# Access Compliance Report

## Public Rights-of-Way

Intersection ID: 10020349	Main Street: BALLANTYNE COMMONS PY	Cross Street: N/A	Location: SE
ADA ID: C08AE0F79F82	Ramp Type: Perp	Initial Pass/Fail: Fail	Overall Compliance: No
		Severity Score: 60	
Codes/Mitigation Info/Possible Solution		Field Measurements/Component Compliance

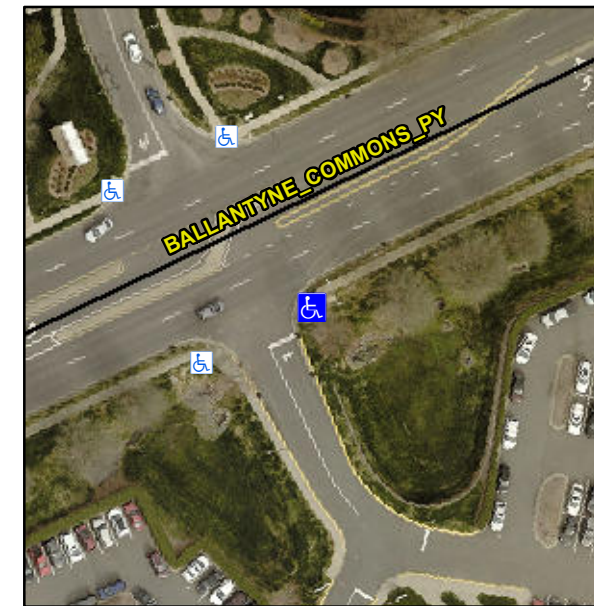
**Not Found, R304.5.1, R304.5.3**

Compliance	Description	Data	Compliance	Description	Data
N/A	Ramp Length (in)	105.0	Yes	Ramp Slope (%)	5.1
No	Ramp Width (in)	29.5	No	Ramp XSlope (%)	9.7
N/A	Flare Type LT	N/A	N/A	Flare Type RT	N/A
N/A	Flare Slope LT (%)	N/A	N/A	Flare Slope RT (%)	N/A
N/A	Flare Traversable LT?	N/A	N/A	Flare Traversable RT?	N/A
N/A	Landing Length (in)	N/A	N/A	DWS Provided?	N/A
N/A	Landing Width (in)	N/A	N/A	DWS Contrast?	N/A
N/A	Landing Slope (%)	N/A	N/A	DWS Length (in)	N/A
N/A	Landing X Slope (%)	N/A	N/A	DWS Full Width?	N/A
N/A	Landing Curb? (Y/N)	N/A	N/A	DWS Offset (in)	N/A
N/A	Shared Landing?	N/A			
N/A	Gutter Ponding?	N/A	N/A	Gutter Slope (%)	N/A
N/A	Gutter Lip Ht (in)	N/A	N/A	Gutter X Slope (%)	N/A
N/A	Painted X Walk1?	No	N/A	Painted X Walk2?	N/A
	X Walk 1 Direction	To W		X Walk 2 Direction	N/A
N/A	X Walk 1 Width (in)	N/A	N/A	X Walk 2 Width (in)	N/A
	X Walk 1 Slope (%)	4.3		X Walk 2 Slope (%)	N/A
	X Walk 1 X Slope (%)	5.5		X Walk 2 X Slope (%)	N/A

**Remove & Replace Entire Ramp.**
